Source:	Prestolite Electric Ltd - Greenford, London, UK
Date:	November 9, 2015
Bulletin No:	TSB4065 rev.1
Models:	AC172TRA (T1 replacement) Alternators
Subject:	PRODUCT CHANGE NOTIFICATION

### AC172TRA DESIGN MODIFICATION

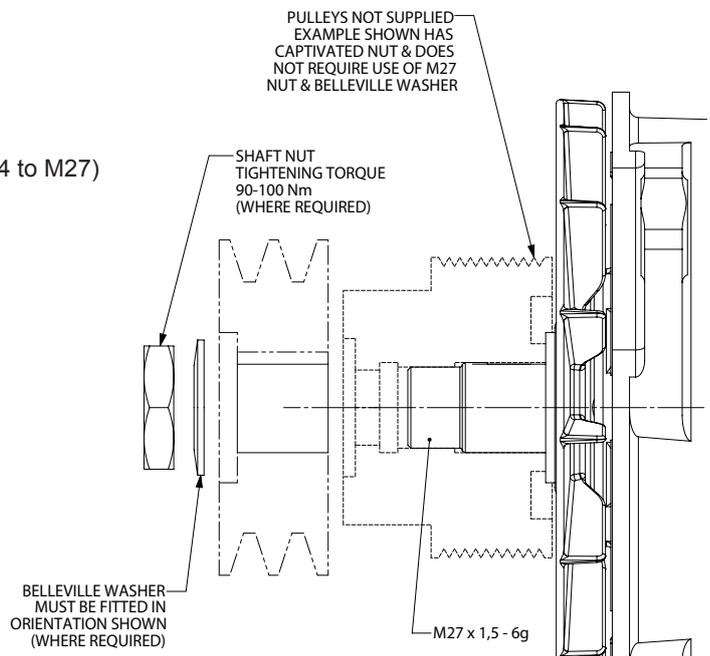
Prestolite Electric have modified the shaft / pulley interface features of the AC172TRA alternators. This is now a direct match to OE manufactured (Bosch / Delco) alternators.

Changes include:

1. Modification of the shaft length.
2. Change of the shaft thread size. (Increased from M24 to M27)
3. Change of the thread length.
